STAFF RECOMMENDATION 1511 Ashwood Avenue November 19, 2018

Application: New Construction - Addition
District: Belmont-Hillsboro Neighborhood Conservation Zoning Overlay
Council District: 18
Map and Parcel Number: 10416034700
Applicant: Alex Sherling
Project Lead: Melissa Sajid, melissa.sajid@nashville.gov

Description of Project: The applicant proposes to construct a rear addition with a ridge raise.

FRONT ELEVATION

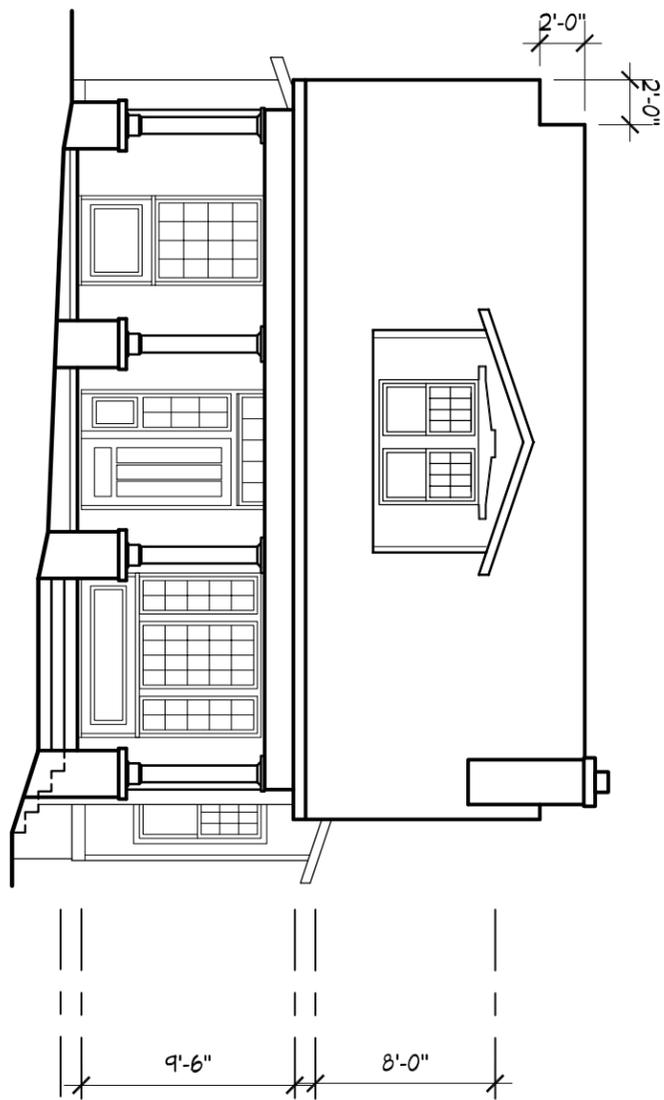
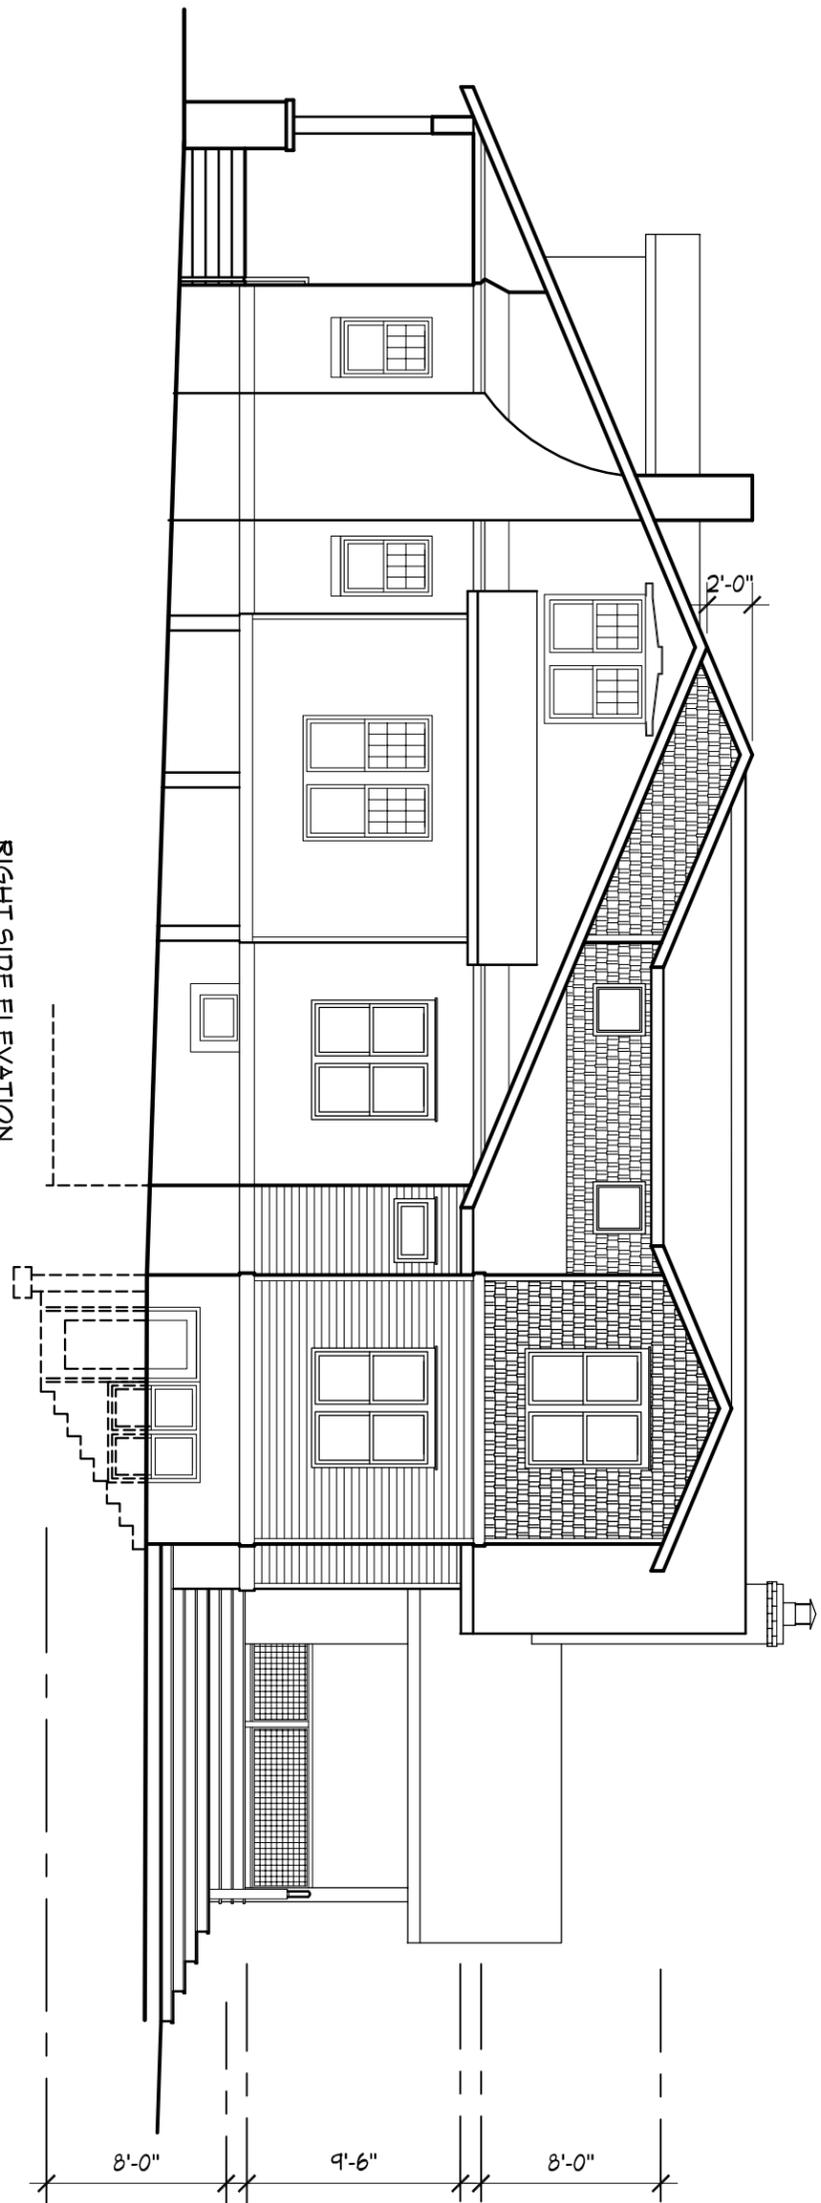
The plan also includes relocating the front door to the center and including a single side light to the left of the door and a transom above. The 1967 photo shows an off-center door with no sidelights and a single window to the left of the door. Staff finds that it is likely that the front façade had already been altered by 1967 since such a configuration is not typically seen historically. Panels below windows (seen on the left window) and window boxes (seen on the right) are more typical of a later minimal traditional style. These elements were likely added to change doors to windows. For this reason, staff finds that a front door with sidelights and a transom could be appropriate. While an asymmetrical design may be appropriate for new construction, staff would recommend that the front entrance design be symmetrical, in terms of the sidelights, as was seen historically.

The proposed addition sets in two feet (2') from both rear corners and goes back four feet (4') on both sides before coming back out to match the width of the house. While it may be appropriate for a one story addition, if separated by an alcove or hyphen, to match the width of an historic house or to even be wider in limited situations, staff finds that the scale of the proposed addition is not appropriate because the roof and eave height are taller, making the form of the addition appear larger and to have a greater number of stories than the historic house.

While the ridge raise and first story insets of the addition are appropriate, Staff finds the scale of the upperstory is not subordinate to the original house. Staff recommends that either the full width of the addition maintain a two foot (2') inset or at least the upperstory is reduced in order to sit two feet (2') inside the silhouette of the historic house to meet sections II.B.1a and II.B.1.b of the design guidelines

1. The front entrance design shall be symmetrical with two sidelights on either side of the new door;
2. The width of at least the upperstory, if not the entire addition, shall be reduced to sit two feet (2') inside the silhouette of the historic house;
3. Staff shall review and approve all materials prior to purchase and installation; and
4. If relocated, the HVAC shall be located behind the house or on either side, beyond the mid-point of the house.

REAR & LEFT SIDE

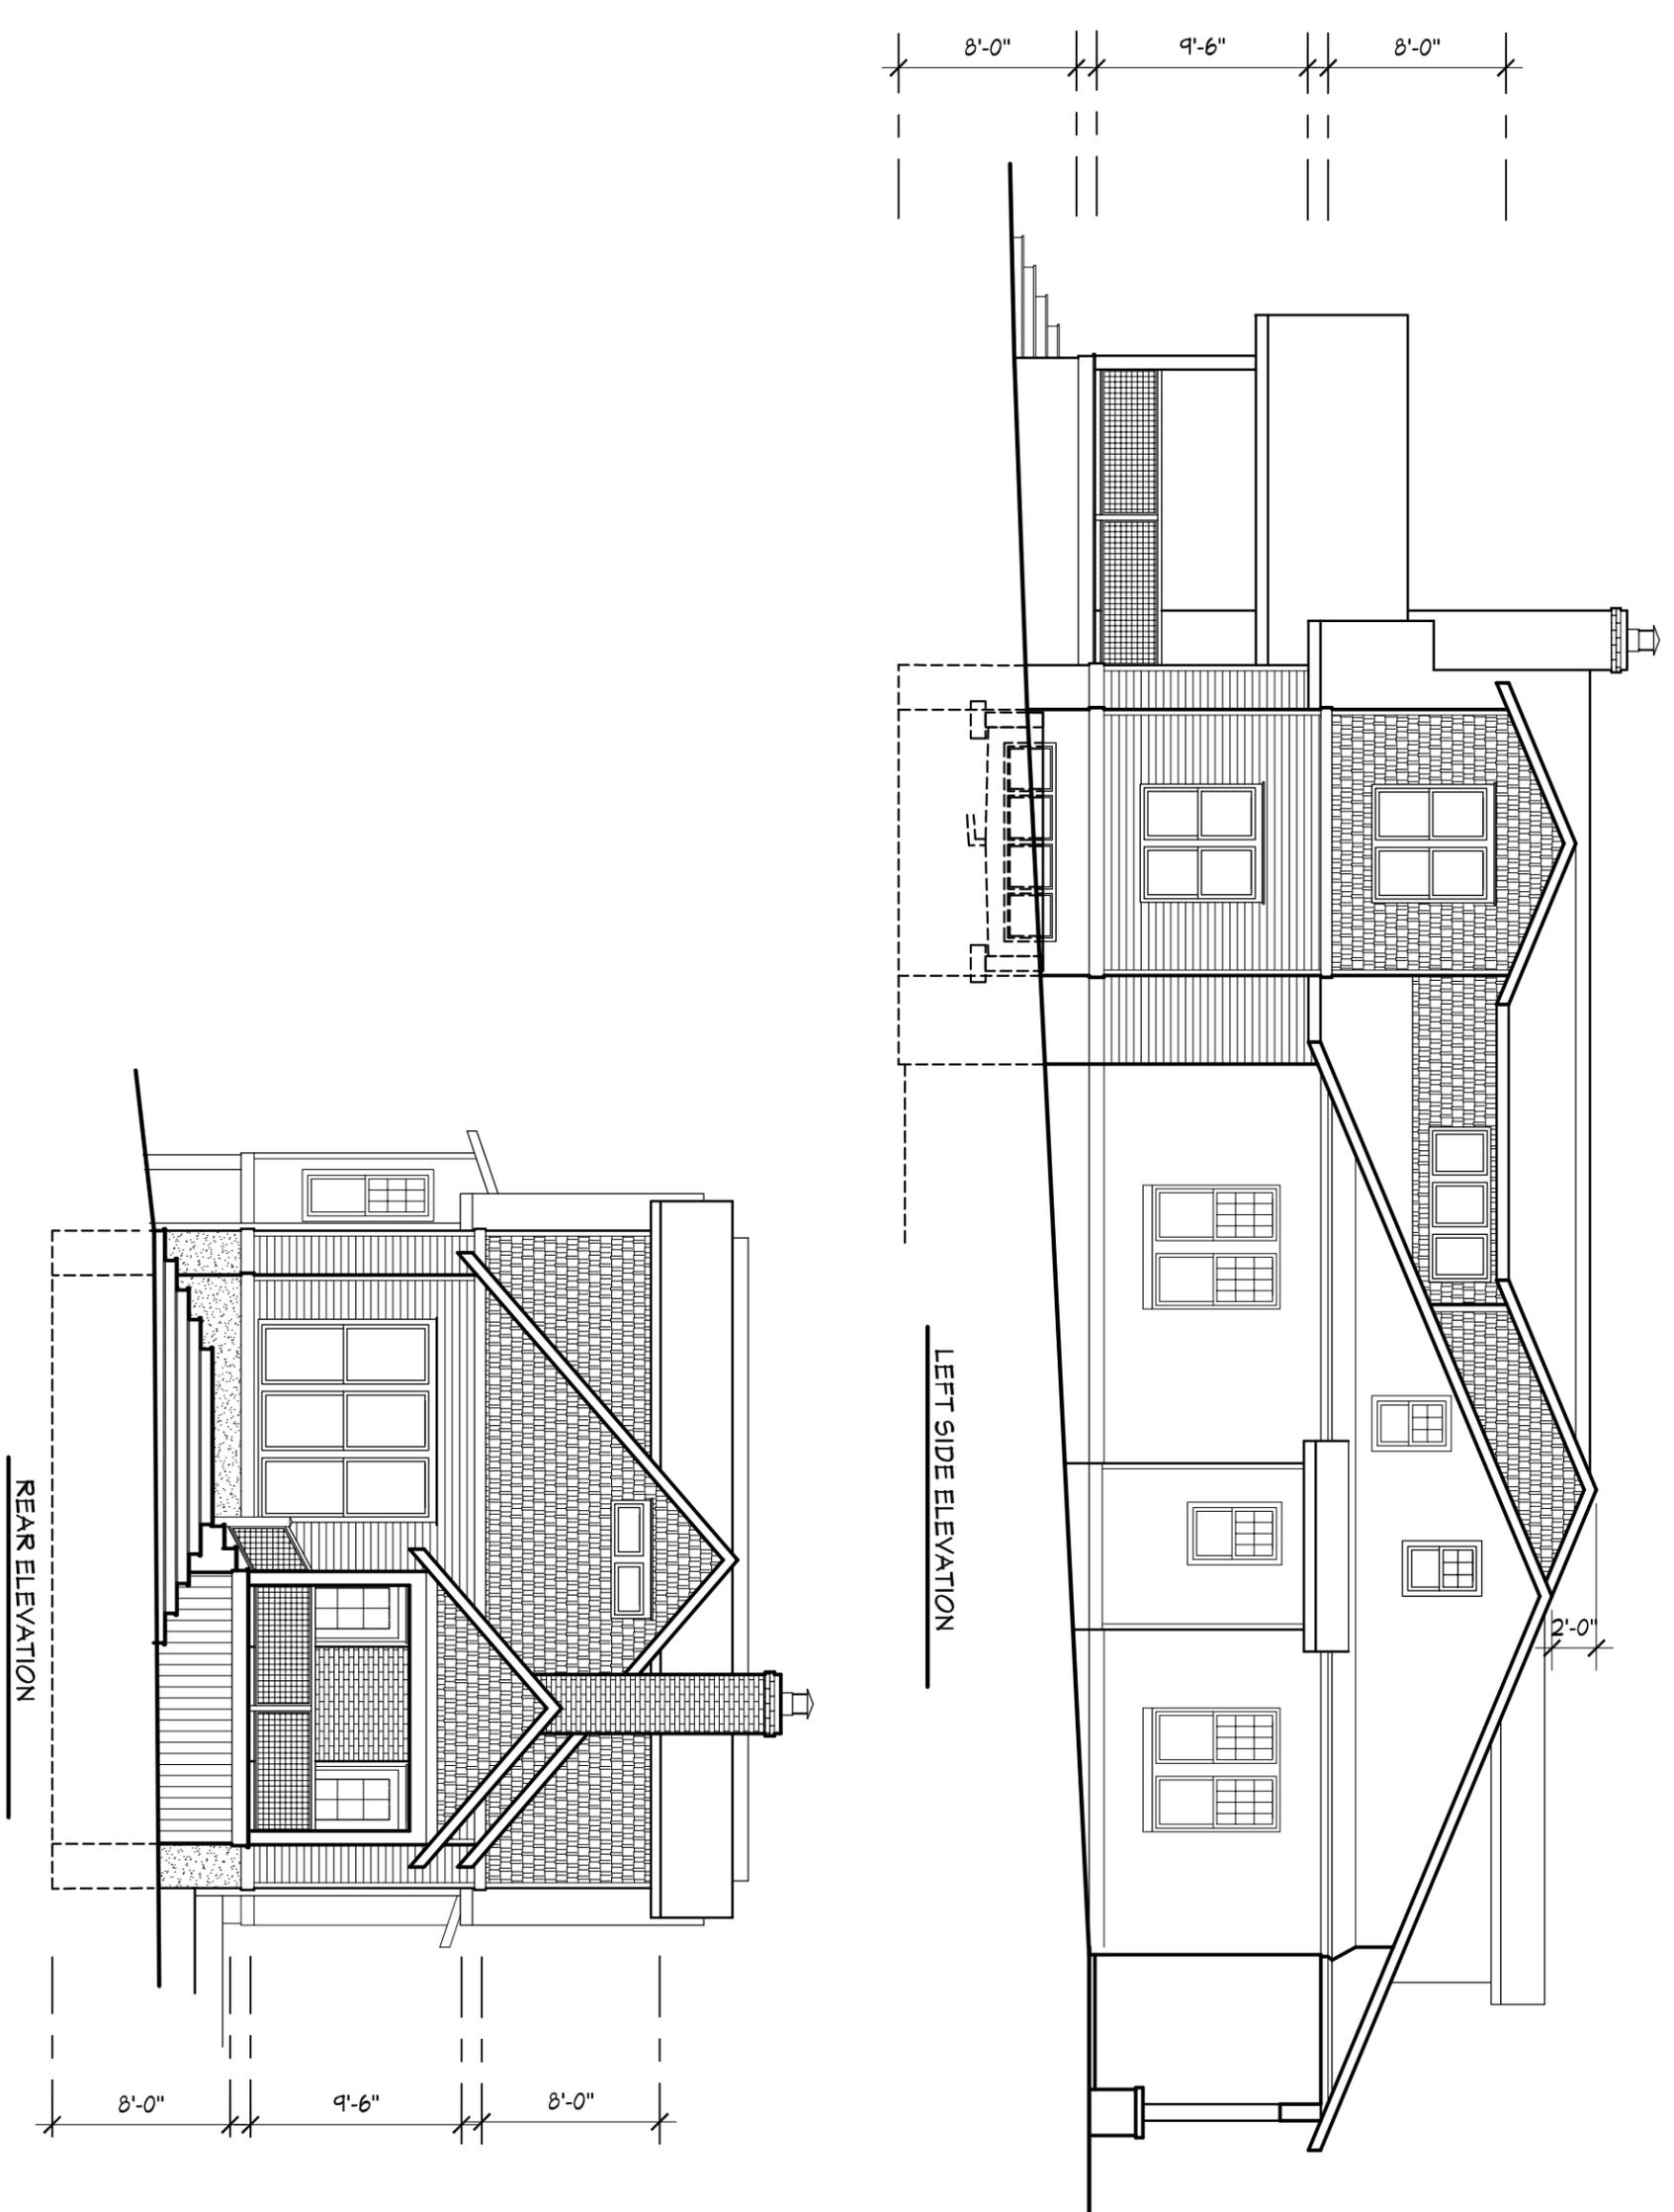
In addition, the plan proposes to remove the exterior stairs on the left side façade and replace the door in the gable field with a window (Figure 1). Staff finds that this is appropriate as the 1951 Sanborn maps show that the house was not a duplex historically (Figure 4).
